Technical Service Bulletin: TSB160011

Released Date: 03-Sep-2019

New Exhaust Gas Temperature Sensor and Injector Quadrant Wiring Harness and Mounting Brackets

Figure 1, Left Bank Wiring Harness Identified By Yellow Tag.

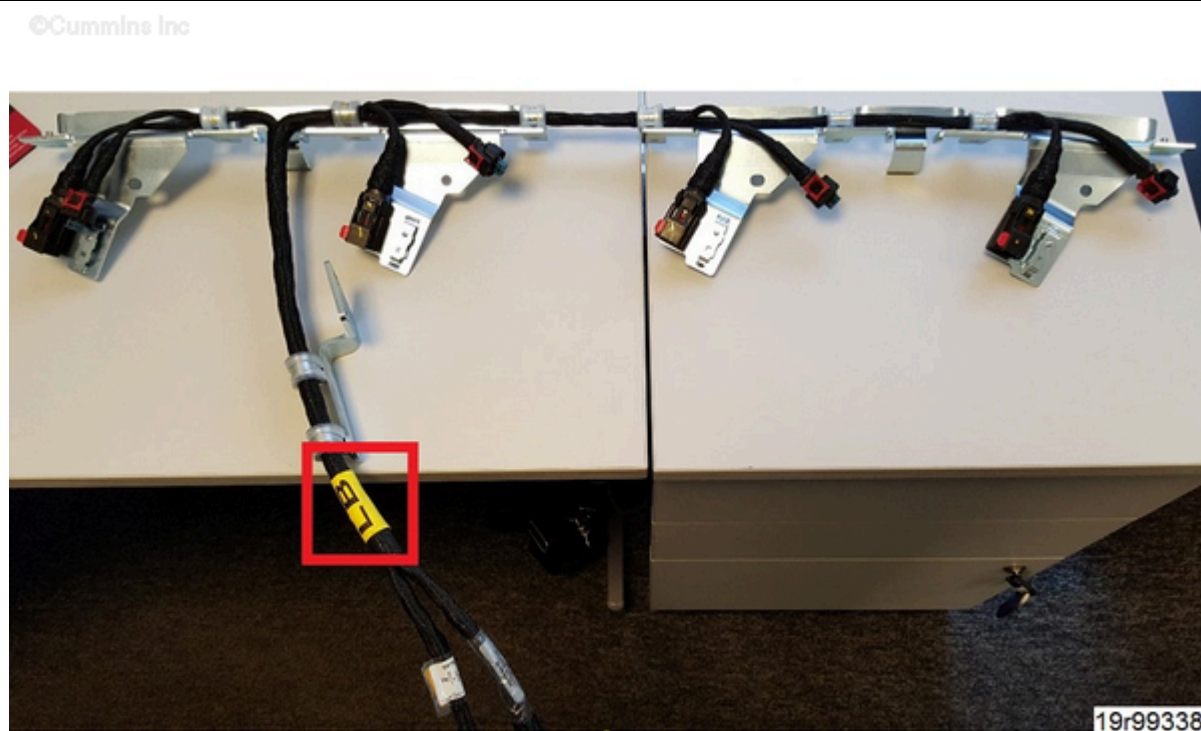
- The cylinder bank (left bank or right bank) on which wiring harness is to be used is identified by yellow tag. See Figure 1 below.

Figure 2, Camshaft Cover Bracket.

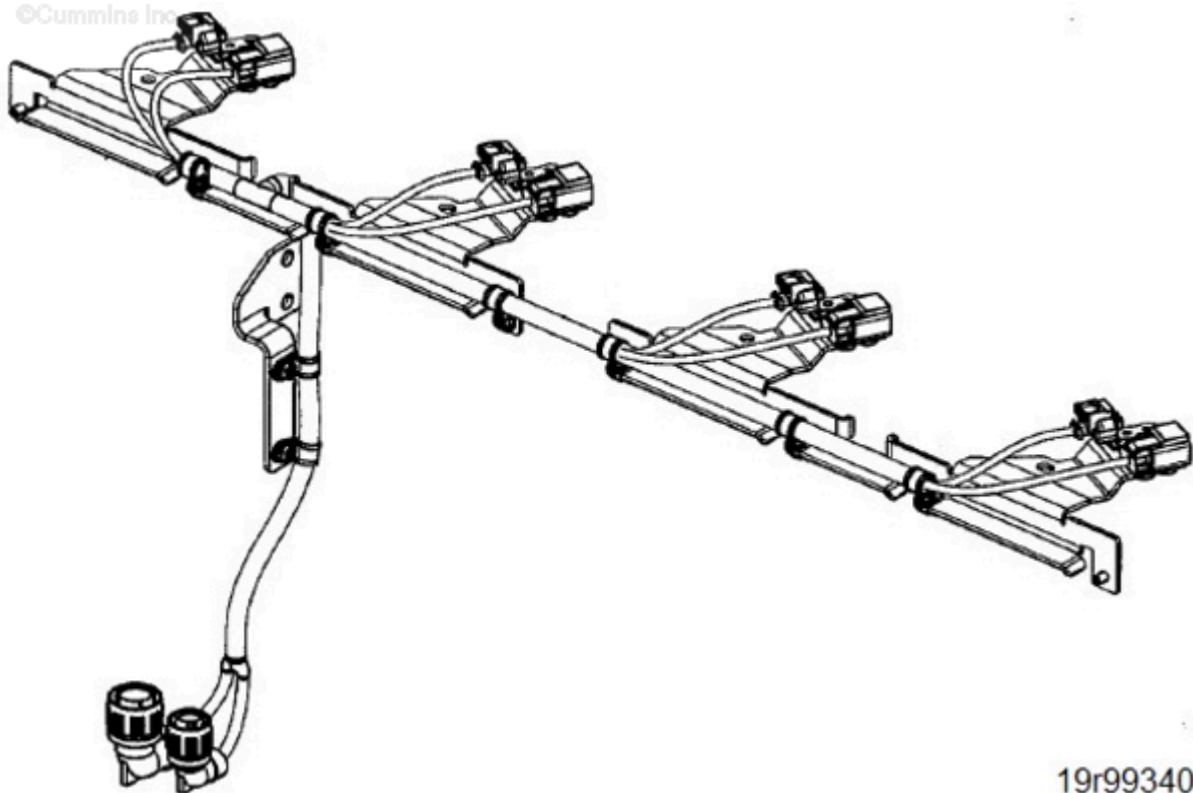
New camshaft cover brackets are also required when installing the new wiring harness and bracket assemblies. The camshaft cover bracket is mounted on the cylinder block and one **must** be installed for every engine quadrant wiring harness used.

- The camshaft cover bracket is same for each engine quadrant. See Figure 2 below.
- The Eliminator™ quadrant wiring harness has a longer main wiring harness connection. See Figures 3 and 4 below.

Figure 4, Eliminator™ Wiring Harness.

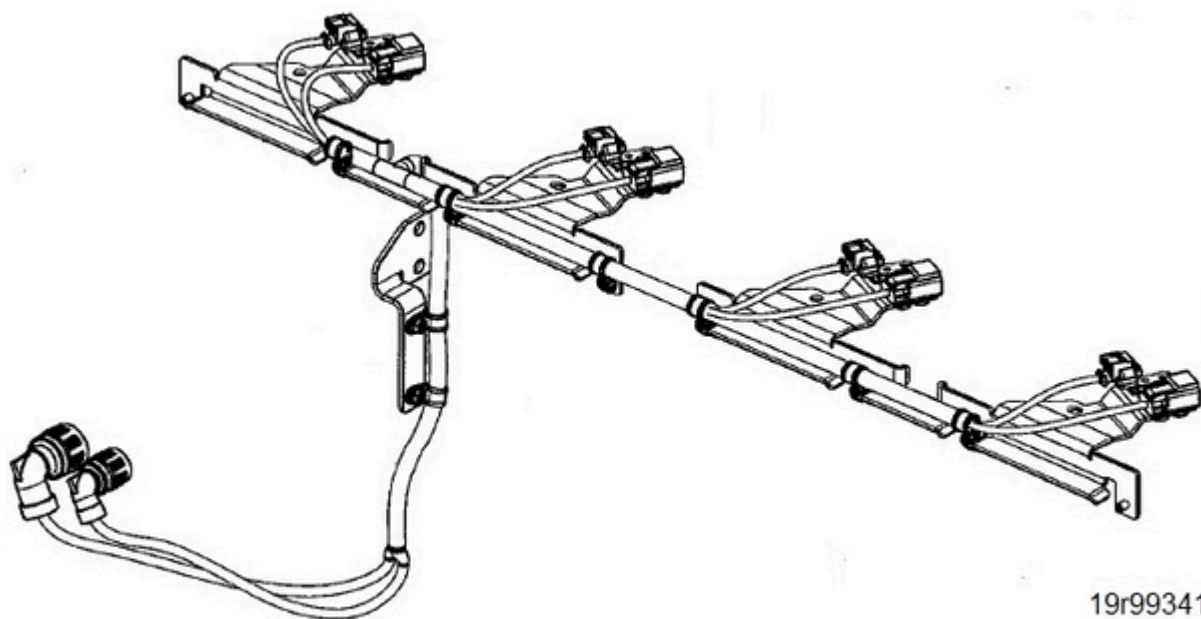
Note : When up-fitting an engine equipped with an Eliminator, use EliminatorTM specific wiring harness, Part Number 5372102, for quadrant above EliminatorTM, all other quadrants use standard harness. See Table 1 above for part numbers. See Figures 3 and 4 below.
